ENVIRONMENTAL REVIEW TEAM REPORT  
ON  
WESTCHESTER ACRES  
COLCHESTER, CONNECTICUT  
MAY, 1975

ENVIRONMENTAL REVIEW TEAM REPORT  
ON  
WESTCHESTER ACRES  
COLCHESTER, CONNECTICUT

Westchester Acres is a proposed subdivision situated in the western section of Colchester, known as Westchester. It encompasses about 45 acres and abuts the southern boundary of the Salmon River State Forest. A stream running northward along the eastern boundary of this site feeds into Day Pond of the Day Pond State Park.

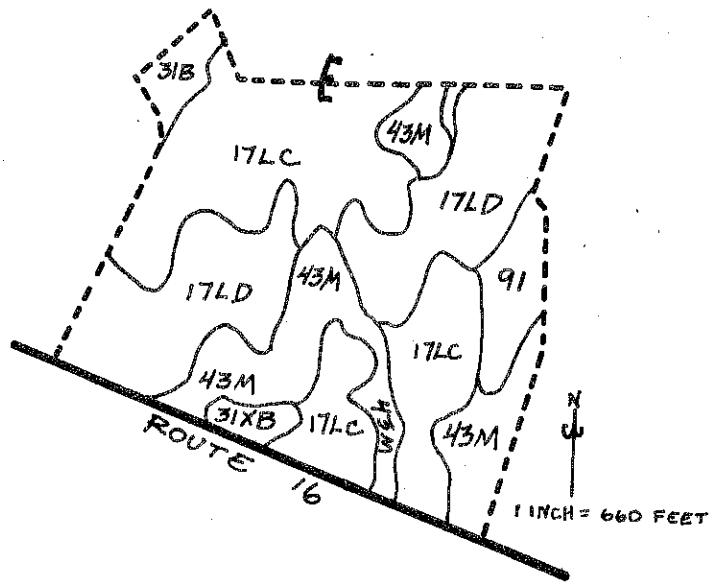
The proposed lots along the wetland to the east, as indicated on the plot plan, appear to extend well into the existing wetland while the front of the lots

are predominantly within the areas of thin overburden and numerous bedrock outcrops. It would appear that without extensive filling of the wetland and/or the front of these lots, severe difficulty in the location of septic systems will be encountered. As was noted earlier, the stream in this wetland flows into a public bathing area. It is important that in the development and future use of this watershed, the quality of the stream water be maintained. Because the wetland is in such close proximity to these lots and serves as the natural surface and sub-surface discharge point for water from these lots, improperly placed septic systems may rapidly discharge their effluent to this body. Not only could this affect the sanitary quality of the water, but an increase of nutrients could also result in algae blooms in Day Pond. Thus, if any lots are to be permitted in this area, thick pockets of overburden materials should be found for individual septic systems and reserve areas and then the lot dimensioned around this. It may be desirable to eliminate the lots directly adjoining the major wetland area.

The layout of the roads as indicated on the present plans present some technical planning problems. On the proposed plan, the road leading to lot 8 is about 1,200 feet in length and the road to lot 23 is about 2,050 feet. Both of these roads end in cul-de-sacs. Although dead end streets can cut down on through traffic, they are not desirable in terms of access of emergency vehicles such as police, fire, and ambulance vehicles. In addition, turn around areas (cul-de-sac) in some cases slow down and prove difficult for such municipal functions as snow plowing. Current

If Victoria Drive, a present dead end street of about 2,000 feet, were extended across the wetland to lot 7, this would eliminate one dead end street on the proposal as well as that of Victoria Drive. However, constructing a road through the wetland will create other problems. Of primary concern would be the sedimentation of the stream and Day Pond during construction. This would be a difficult problem to control and could not be entirely prevented. There is also a question of sand and salt from the roads gaining direct access to the stream once the road is in use. In arriving at a decision the benefits of constructing the road will have to be weighed carefully against the hazards during and after construction.

The subdivision regulations also require two access points for subdivisions over 30 lots. If the road ending at lots 26 to 29 could be returned to Route 16, this would shorten the dead end road to lot 23 as well as provide a second access. However, steep slopes present problems at possible access points to Route 16 at lots 27, 28 and 38. If the number of lots are reduced, a single access road would meet the requirements of the subdivision regulations.

Development of the lots adjoining the major wetland present the greatest concern. Due to ledge, slopes, and the wetland, proper placement of on-site sewage disposal systems will be difficult. A reduction in the number of lots or possibly the elimination of the lots alongside the wetland is recommended. Suitable locations for septic systems and their reserve areas should be the prime consideration. If lots are developed in this area, specific erosion control measures should be included as part of the plans.
